© 2016 Mazda Motor of America, Inc.

<b>Subject:</b>  A/C BLOWS WARM AIR	<b>Bulletin No:</b> 07-006/16
	<b>Last Issued:</b> 12/12/2016

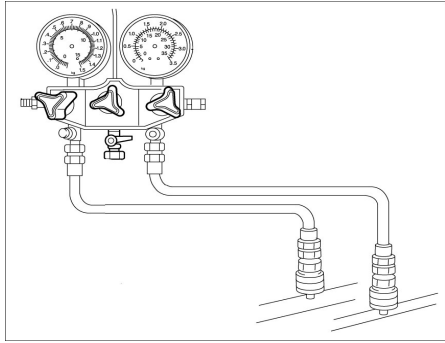
Some customers may complain about warm air from the climate control vents. This may be caused by improper brazing (A) of the evaporator (B), causing a refrigerant leak from the joint between the tubes (C) and the header (D).

1. Verify customer concern.
2. Use a dealer supplied manifold gauge tool to check the A/C refrigerant charge. Refer to MS3 online Workshop Manual REFRIGERANT PRESSURE CHECK. Is the A/C refrigerant charge low?
  - Yes - Go to step 3.
  - No - This Service Information is not applicable. Refer to MS3 online Workshop Manual NO COOL AIR [FULL-AUTO AIR CONDITIONER].
3. Use a dealer supplied UV leak detection tool. Is there a trace of fluorescent liquid at the A/C unit drain hose end?

- Yes - Go to step 4.
  - No - This Service Information is not applicable. Refer to MS3 online Workshop Manual NO COOL AIR [FULL-AUTO AIR CONDITIONER].
4. Replace the A/C evaporator. Refer to MS3 online Workshop Manual A/C UNIT REMOVAL/INSTALLATION.

**NOTE:** When replacing the evaporator, add compressor oil of approximately 40 ml {40 cc, 1.4 fl oz}. Refer to MS3 online Workshop Manual REFRIGERANT CHARGING.
5. Verify repair.

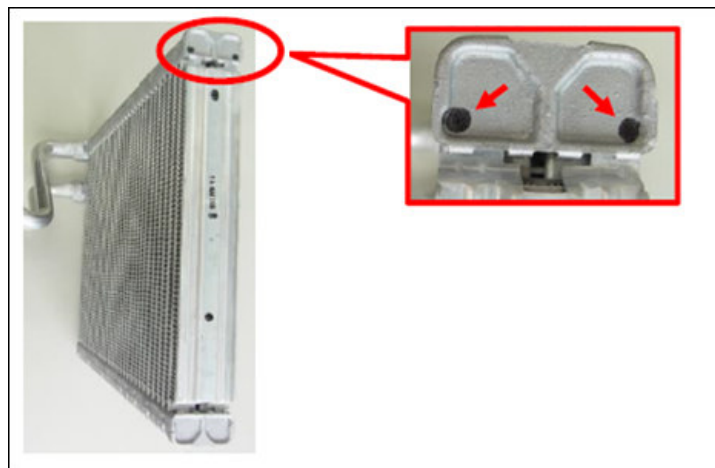
**NOTE:** Modified part can be distinguished by its black circled marking as shown below.
